AMENDMENT OF SOLICITATION/MODIFICATION OF CONTRACT	1. Contract Number	Page of Pages 1 of 87

2. Amendment/Modification Number	3. Effective Date	4. Requisition/Purchase Request No.	5. Solicitation Caption
DCAM-2008-B-0054-005	6/30/2008		Construction of Ward Six Senior Wellness Center

1. The modified Sections of this IFB as indicated in Amendment No. 5 includes: Responses to Questions (Attachment A), Interior Signage dated 06.20.08 (Attachment B), Lower Level Lobby Medallion Dimensions (Attachment C), Radiant Heating Electric Cable Specifications dated June 26, 2008 (Attachment D), Sheet D1.1 Revised 06.26.08 (Attachment E), Sheet D1.3 Revised D1.3 Revised 06.26.08 (Attachment F), Hayes Senior Wellness Center Building Dedication Plaque (Attachment G), DDOT Standard Covered Walkways, Sketch 7 & 8 Pedestrian Canopy (Attachment H), E-1 Rev. 1 (Attachment I), E-05 Rev. 1 (Attachment J), E-06 Rev. 1 (Attachment K), E-07 Rev. 1 (Attachment L), E-10 Rev. 1 (Attachment M), Section C.3 Drawing List Rev. 2 06.25.08 (Attachment N), Inspector's Office (Attachment O) Add: to Section H of solicitation package, A1.2-Rev, A1.3-Rev, A1.5 Rev, A6.1-Rev, New A10.1 (Attachment P), Section C.3 Drawing L

Sheet D1.1 Revised 06.26.08

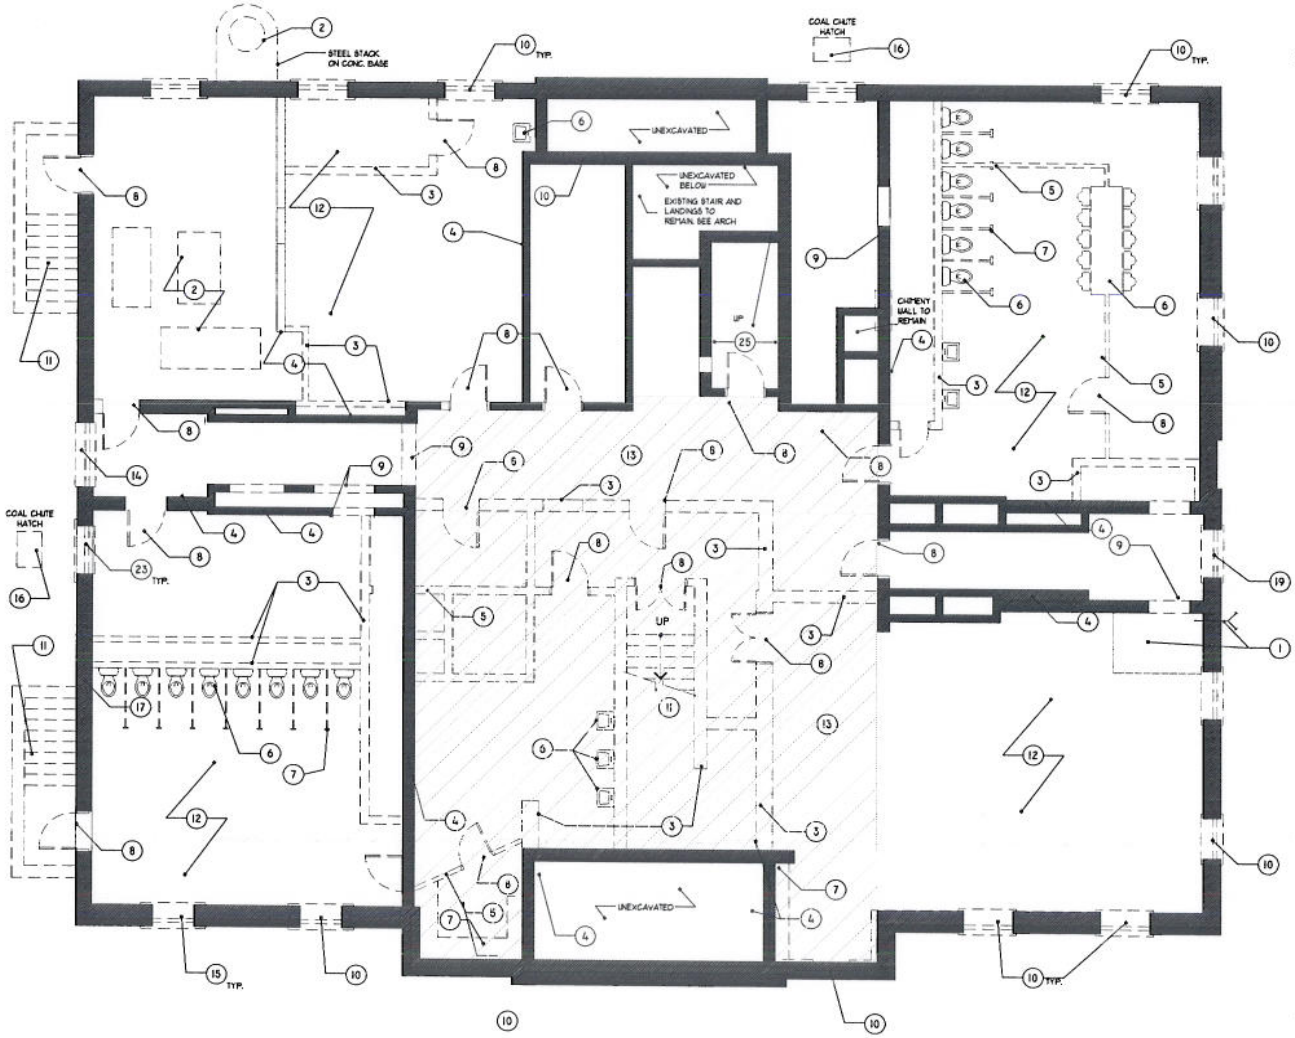
Answer: **See attached "hatching" clarification for D1.1. Demolition note 13 deleted from north corridor.**

Sheet D1.3 Revised 06.26.08

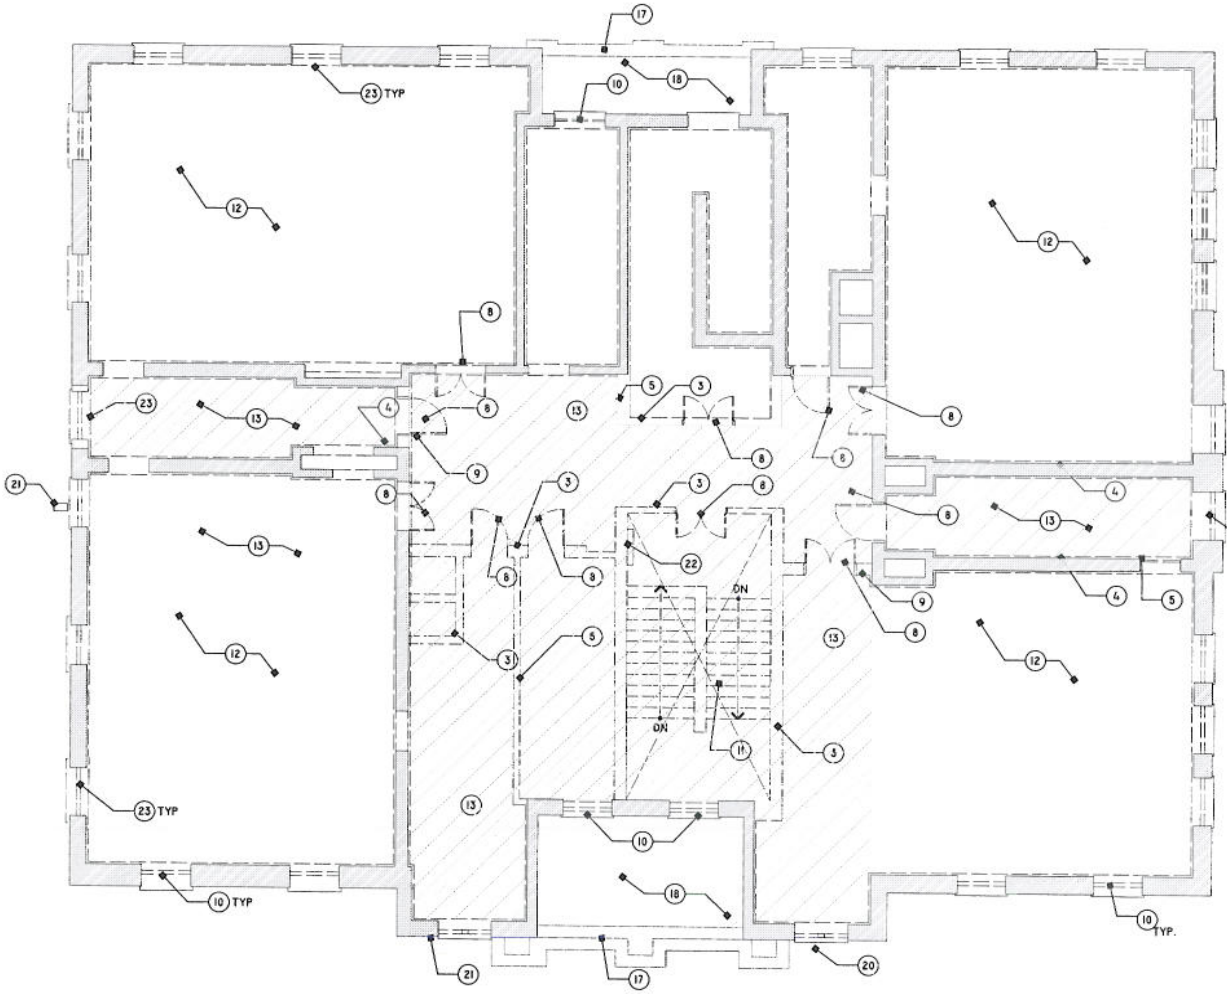
Answer: **2x12"@16" o.c. is correct and the corridors require new floor. Demolition will be required at north & south corridors (see attached D1.3)**
